READ ME

This “READ ME” file is presented to facilitate the review of the Department of Energy *Waste Isolation Pilot Plant Hazardous Waste Facility Permit Amended Renewal Application*, September 2009 (Renewal Application). It is intended to provide information on the organization of the Renewal Application. The organization of the Renewal Application was developed to identify the regulatory requirements for a renewal application and provide the information that addresses those regulatory requirements.

Figure I-3
 WIPP Facility Final Closure Schedule
 RENEWAL APPLICATION CHAPTER I
 Page I-33 of 36

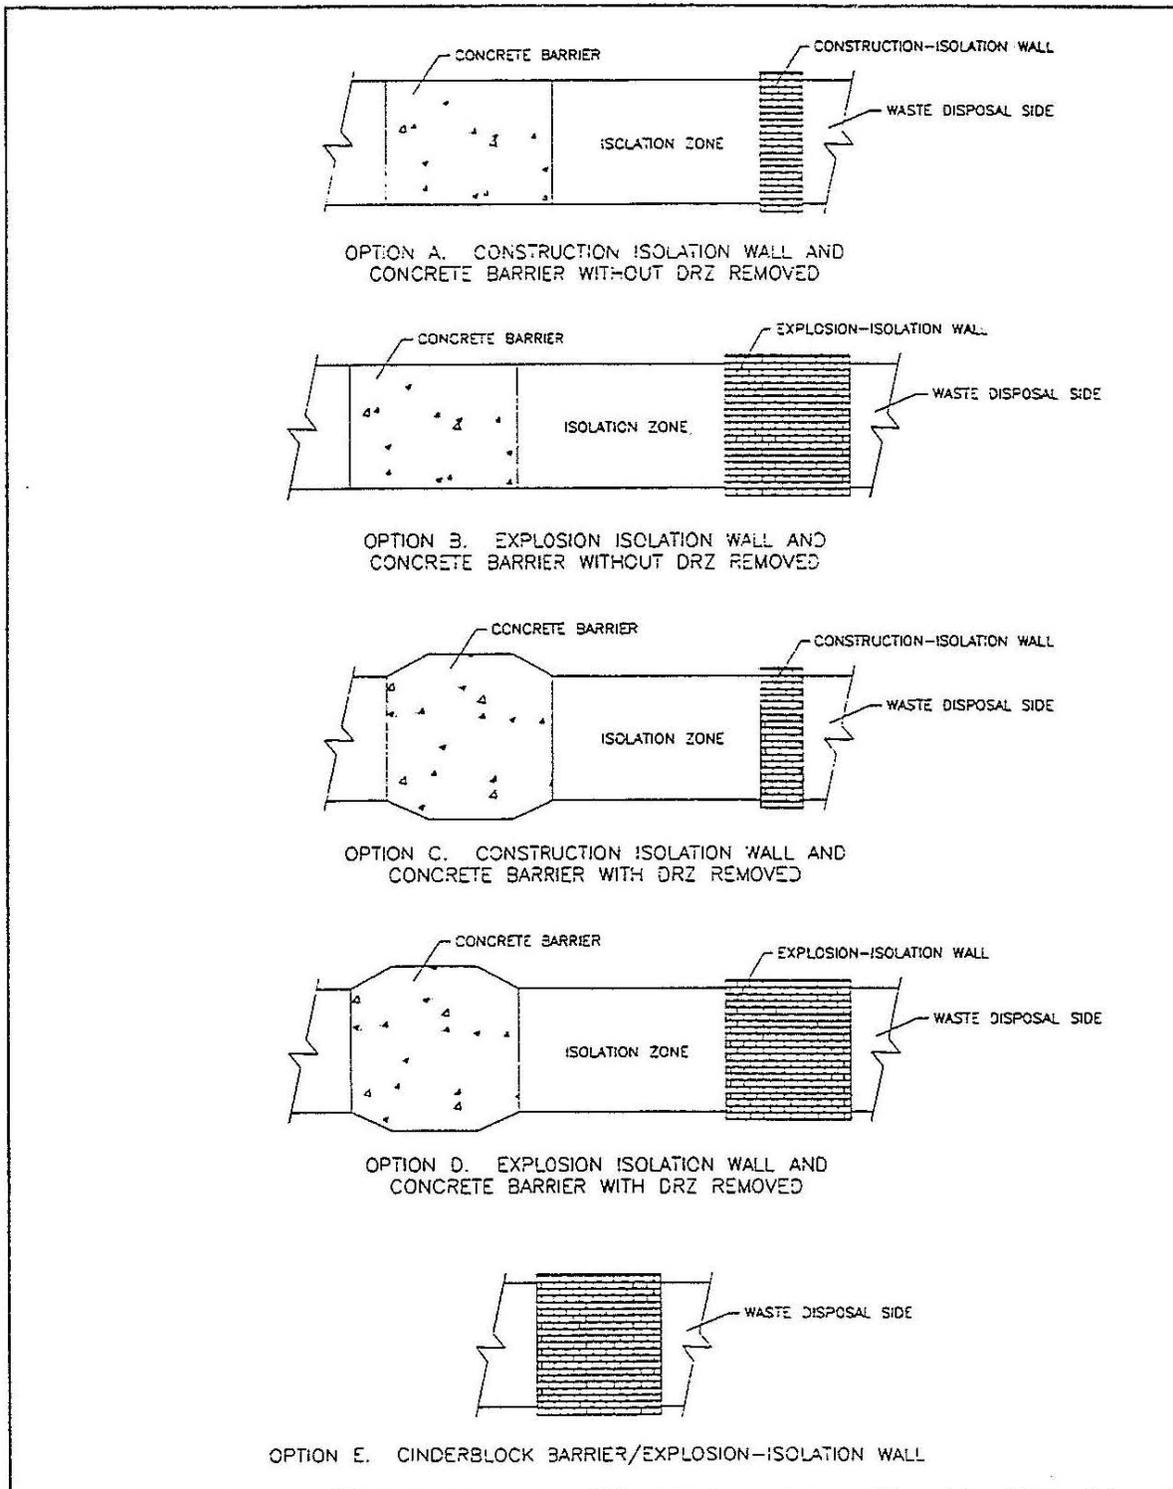
- xvi. Page I-26 & I-33: The dates in Figure I-3 don't agree with the dates in Table I-2.
- xvii. Appendix I-3, Page I3-3: First, update the SAR reference to the 2008 combined CH-RH DSA on lines 25 and 28. Second, on line 35-36, WIPP procedure WP-12-HP1100 is not included in the current Permit but rather is only available in the WIPP Operating Record. Also, the date for that procedure should be changed to 2008 – the date of the last revision.

Figure I-5
 Typical Disposal Panel

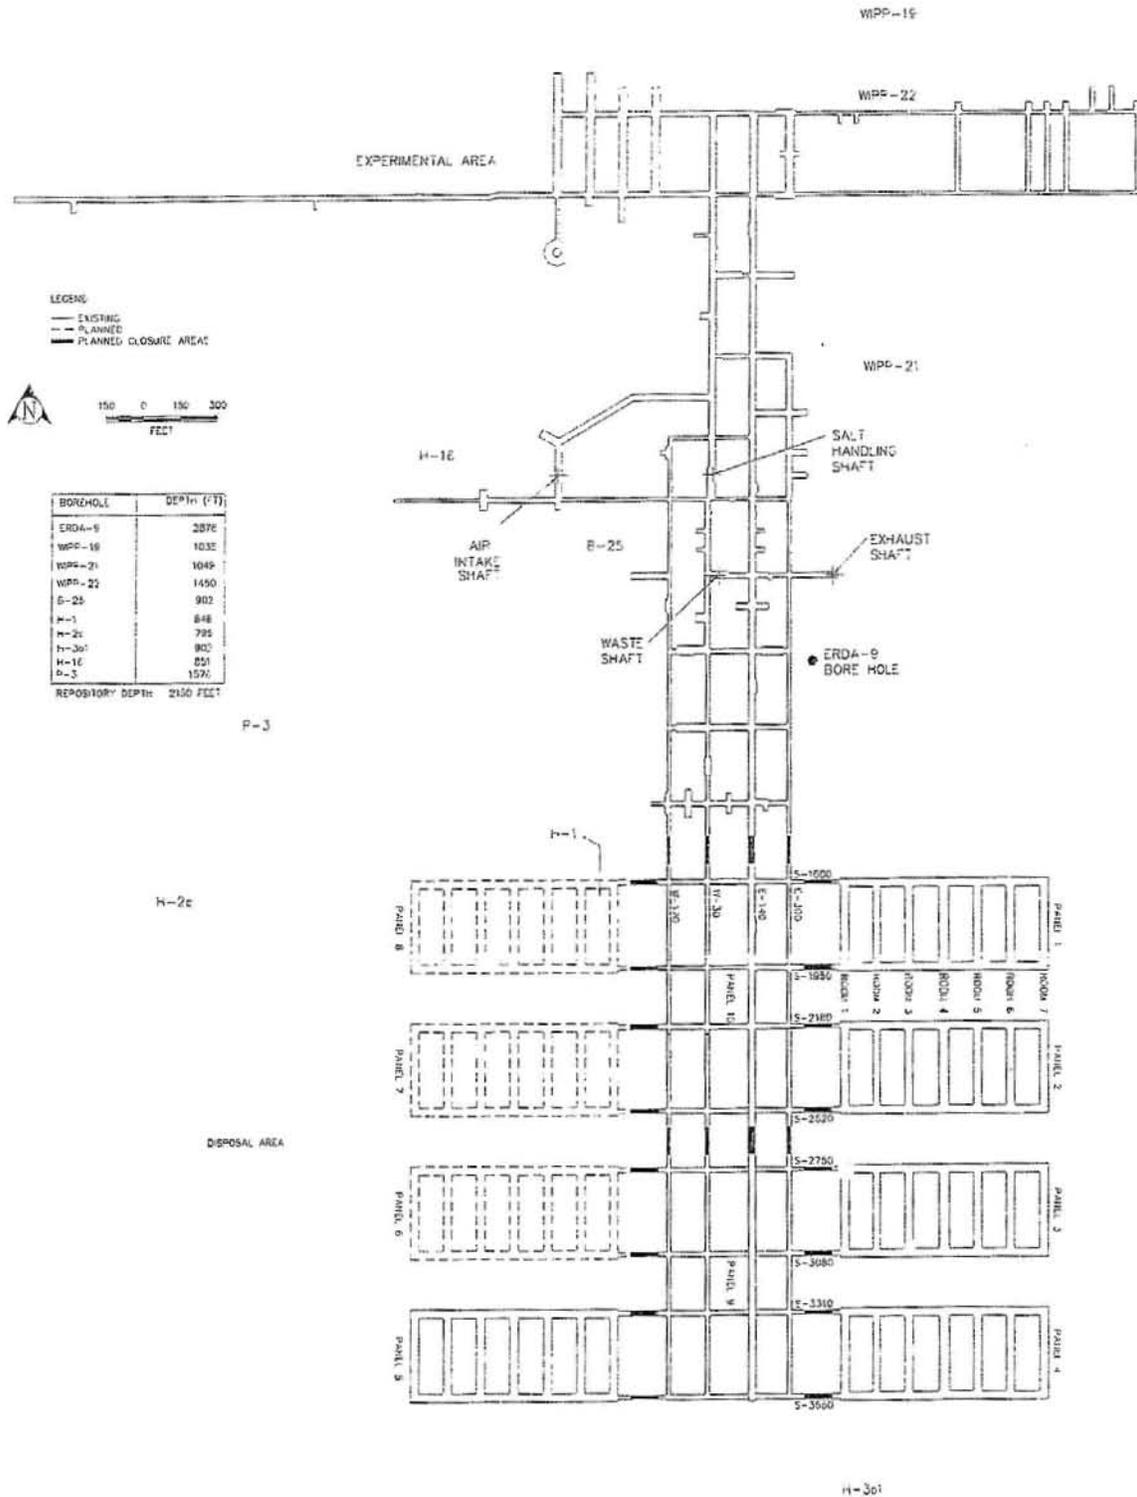
Page 2, lines 33 & 34: Since Panels 9 and 10, as currently planned and shown on various figures in this renewal application (Part A, Figure 3-2 for example), will not have seven rooms, the text on line 33 should be modified.
